## URBAN DESIGN PANEL

## RESPONSE TO URBAN DESIGN PANEL COMMENTS \_ ENTRANCE LOBBIES

**Re: Proposed Hotel, cnr Cambridge Terrace and Worcester Boulevard.**

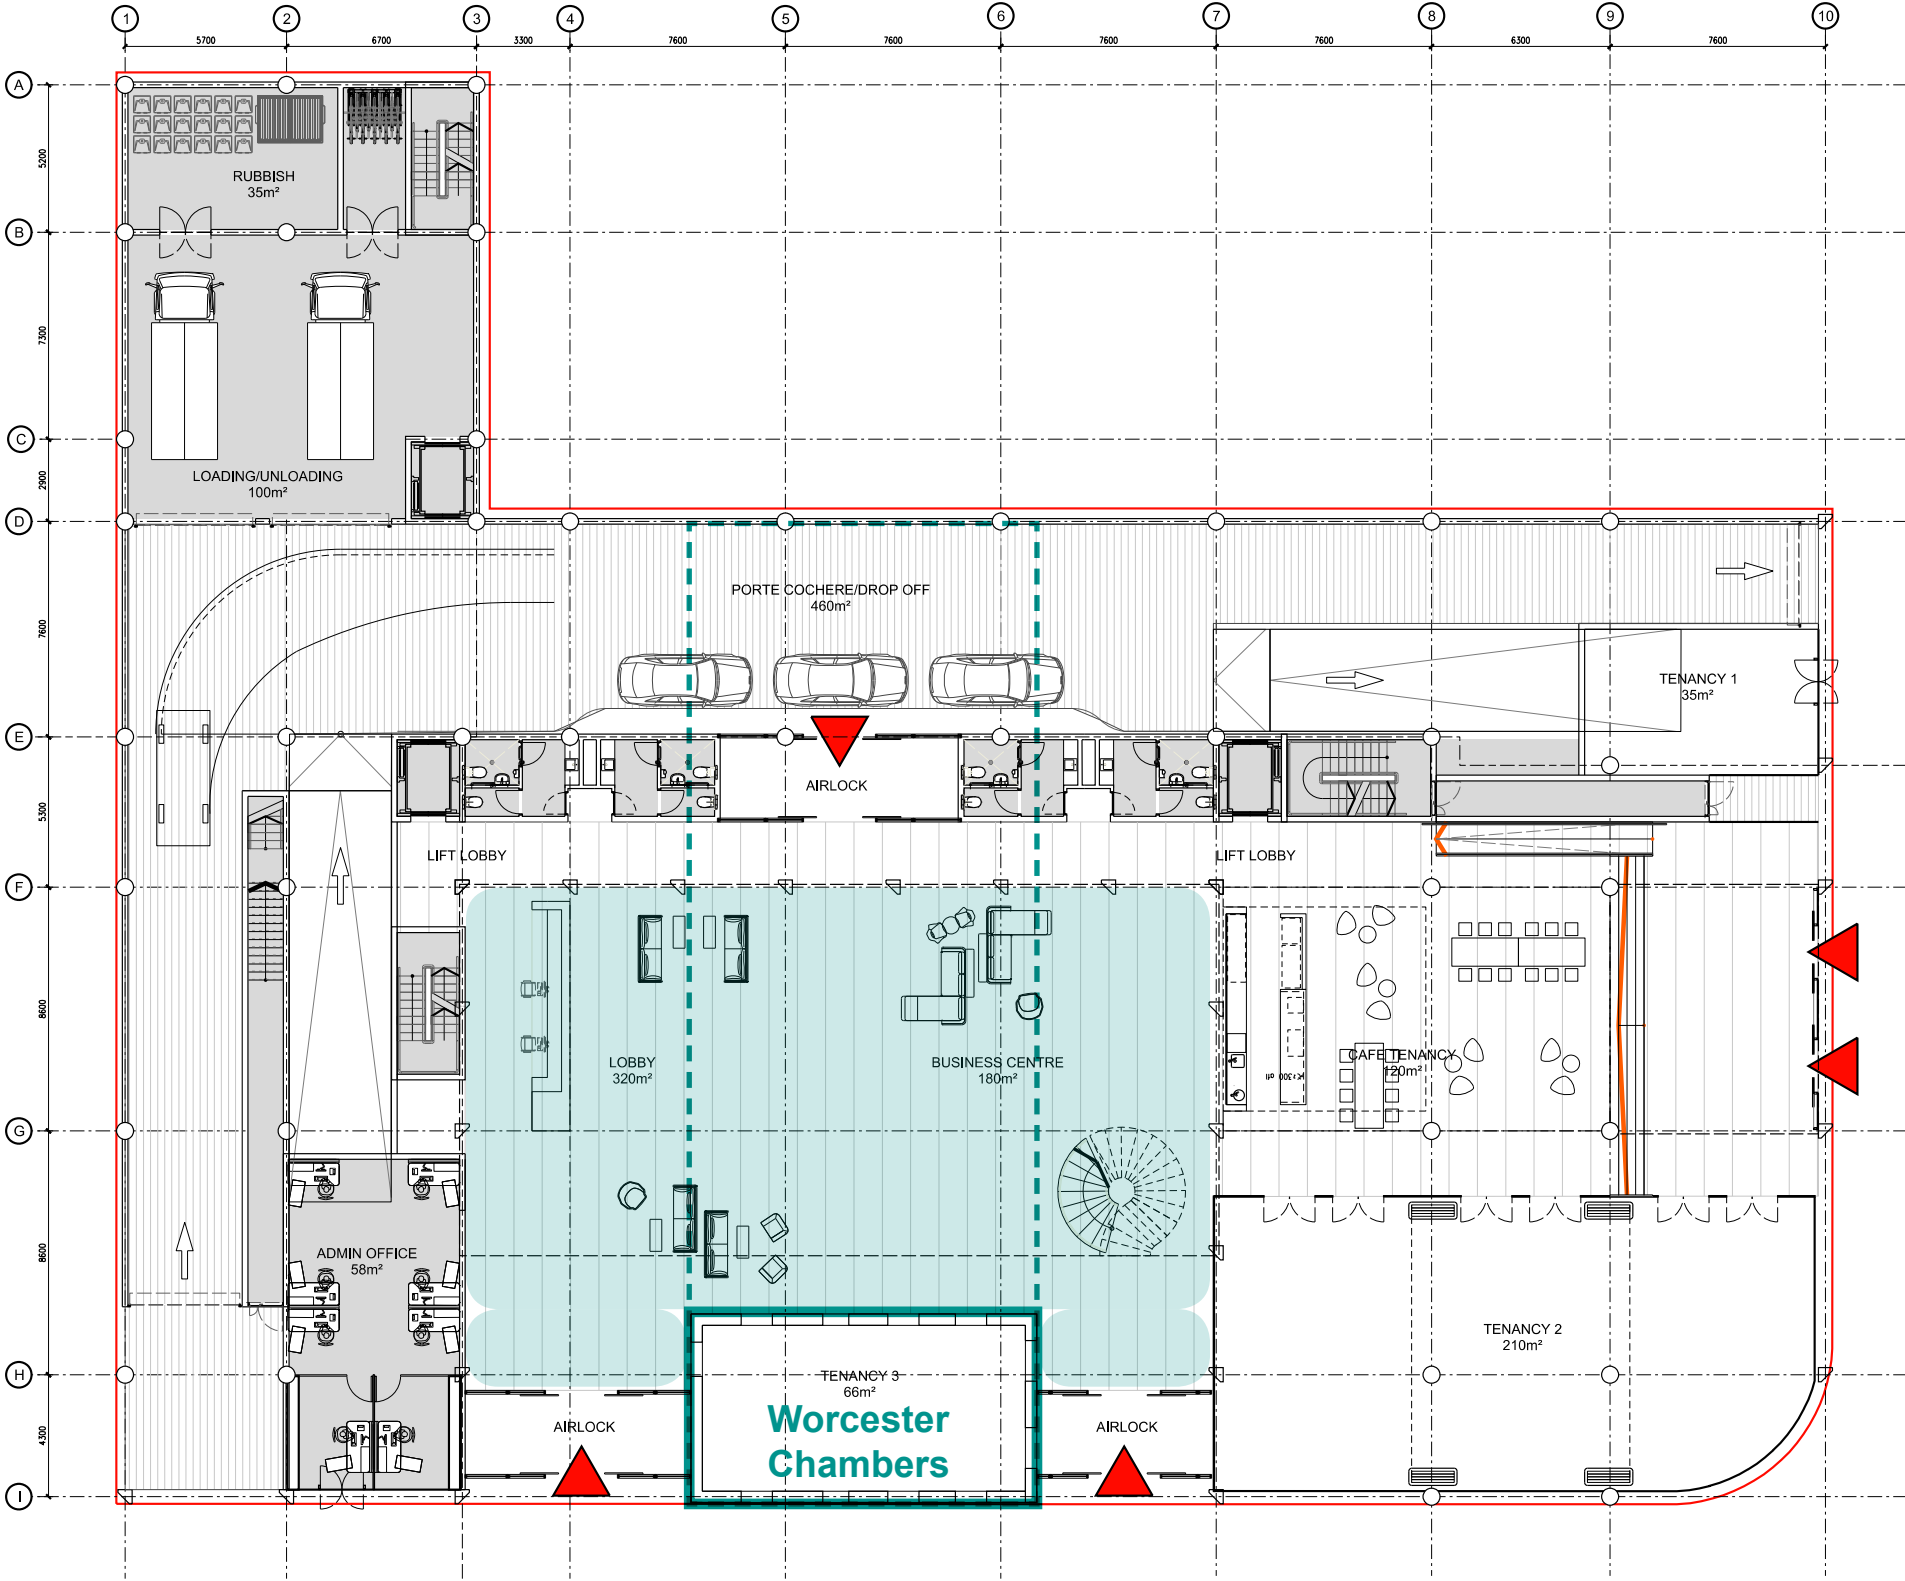
5. Supports the sympathetic retention and incorporation within the proposal of part of Worcester Chambers, in such a way that it is read as three dimensional and intact heritage building. Refer to secondary matters below for further detail.

2.	Suggests some matters for consideration in the partial retention of Worcester Chambers:
•	Revealing more of the heritage built fabric to the public realm by pulling back the air lock chambers/ meeting rooms over from the street.
<i>This has been addressed in the appended documents by decreasing the width of the enclosure to the entrance lobbies and setting them back more than previously, with the effect exposing more of the side walls of Worcester Chambers.</i>

Images showing detail of entrance lobbies flanking Worcester chambers allowing the retained portion of the building to read three dimensionally rather than a façade only .

ENTRIES RECESSED TO EXPOSE FLANKING WALLS

### GROUND FLOOR \_ OPTION 02 \_ RETENTION 50%

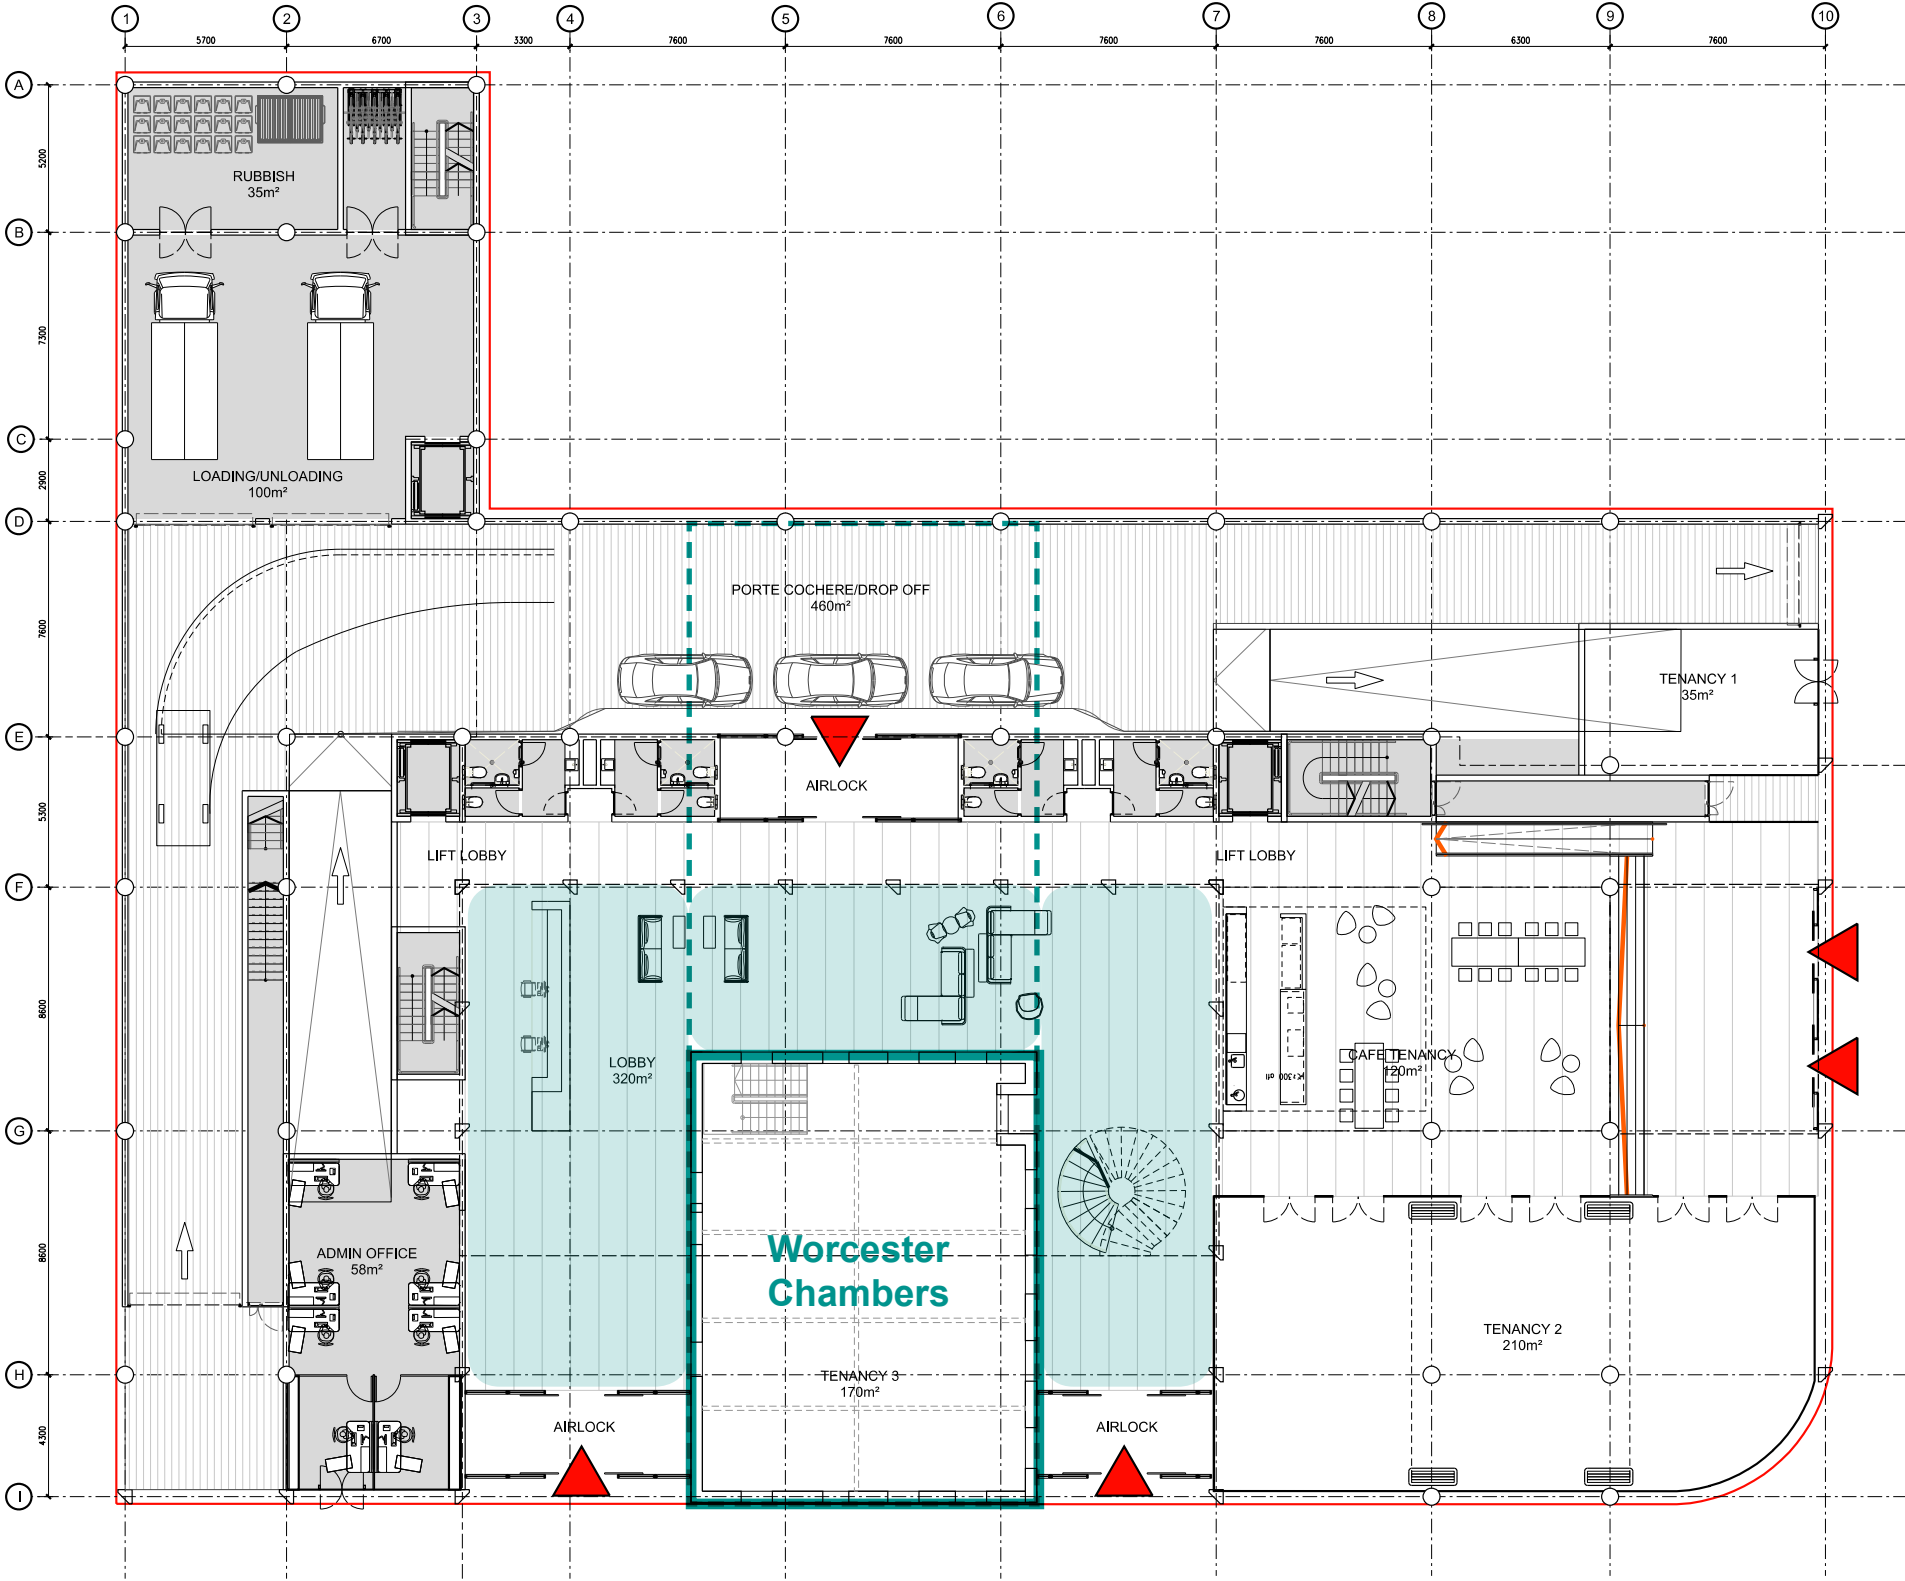
•	Exploration of the extent to which the Worcester Chambers are retained and provides a clear articulation of the rationale for this.
<i>We have considered the rationale for the retention of part of Worcester Chambers as follows:</i>	
<i>The composition of the proposed hotel is built around the proposition that in the alignment of the concave space between the guestroom wings above with the ground floor public spaces, a glass roofed atrium can be formed at the ground floor that abuts the ‘front rooms’ of Worcester chambers. The atrium is required for the hotel function. The rooms within the Worcester Chmabers building would be refurbished as hospitality spaces.</i>	
<i>In this way the retained portion of Worcester Chambers which is approximately 6.5m deep would function as a room off the atrium space and an address off the street. Its function is likely to be a small food and beverage outlet linked to the atrium, or a small retail unit.</i>

Pros	Cons
More of Worcester Chambers is retained than Option 1	The atrium design and function will be severely compromised
Retaining a 50% component will allow the existing stair and redundant safe and several heavily modified existing rooms to be retained	There will be no way to integrate these items into the hotel because of their location and function
Retaining more of Worcester Chambers enables the existing rooms to be intact back to the stairway	Smaller rooms are not required for the Hotel function in this location

## RESPONSE TO URBAN DESIGN PANEL COMMENTS \_ FINISHED FLOOR LEVEL

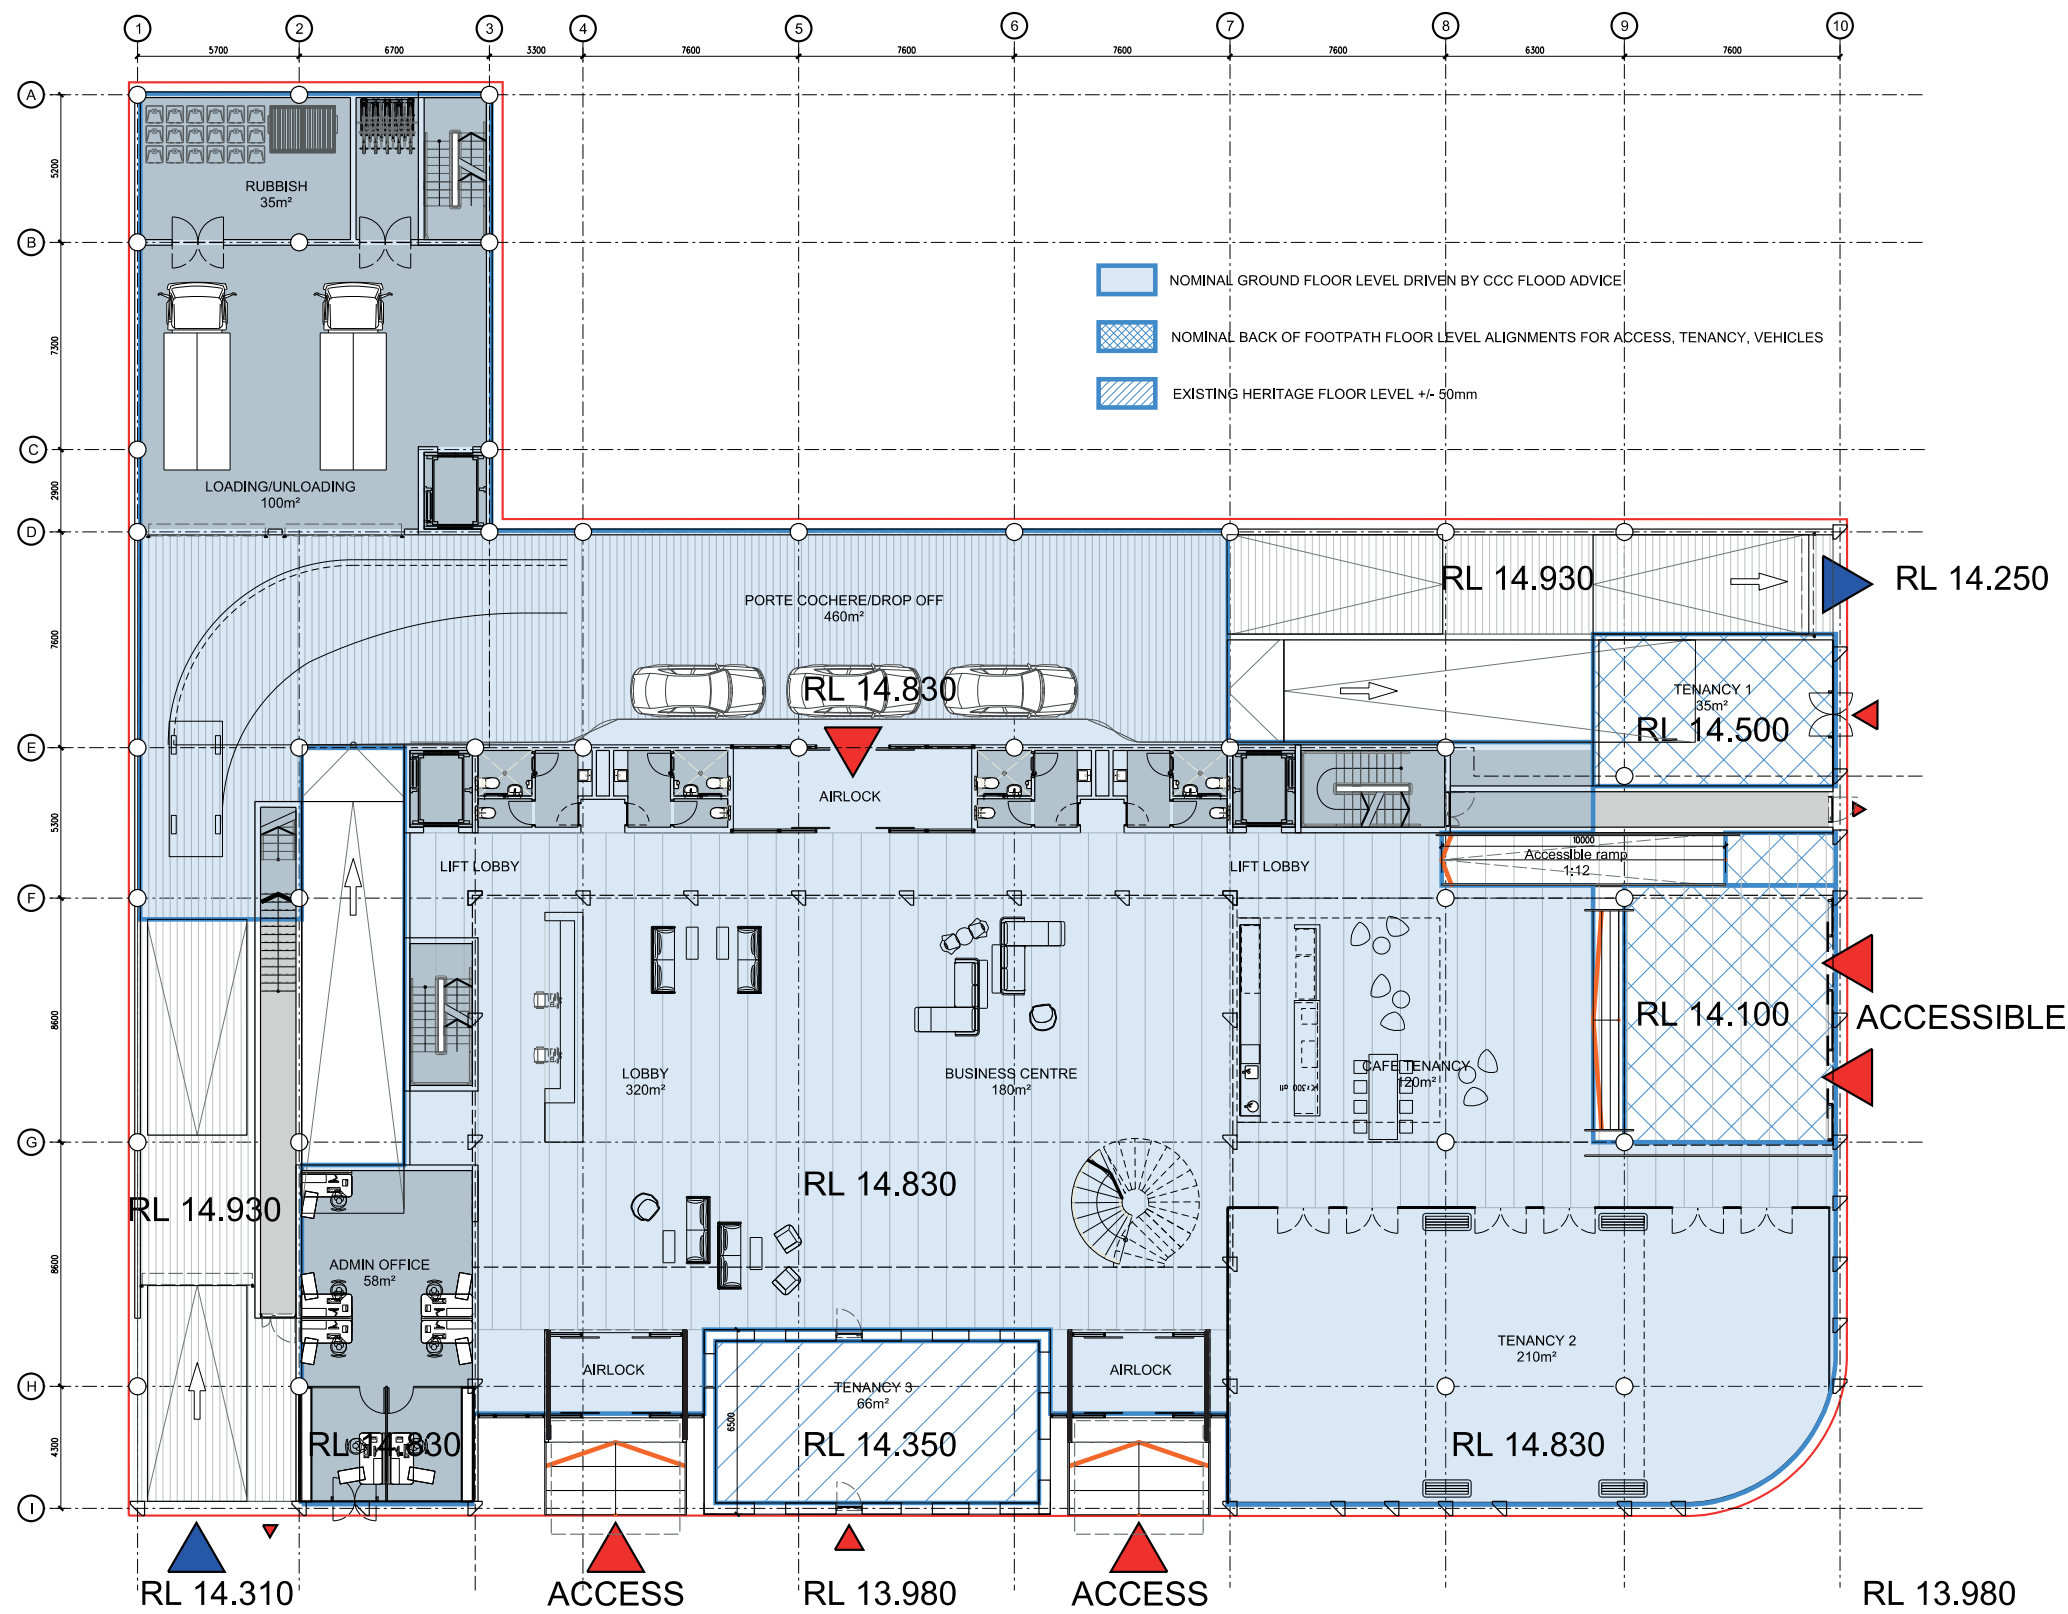
4. Considers that there is potential for good active uses for both street frontages and increased visibility and connection between the internalized spaces and the exterior public domain. Activation could be increased through improved access to the streets and careful consideration of the use of separate tenancy spaces.

11.	Encourages elegant and accessible resolution of level change between streets and interior.
Agreed, for further development	
12.	Notes the opportunity for the Cambridge Terrace entry to visually connect with the Ōtākaro (Avon) river and enco urages attention to the entry sequence.
Agreed, for further development

The requirements to comply with a minimum Flood plain floor level and the desire expressed by the Urban design panel to develop the street edge including the corner as accessible and active street frontage are to some degree in conflict. Our plan enclosed shows the proposed levels following the advice of both parties, whereby a larger portion of the floor plan is set at the flood plain level advised by the CCC, and the smaller tenancy areas on the edge and the Worcester Chambers building are kept at levels enabling them to relate to the floor, and the existing level in Worcester Chambers. We believe this is a viable compromise, supported by some mitigation measures in construction of the lower tenancies.
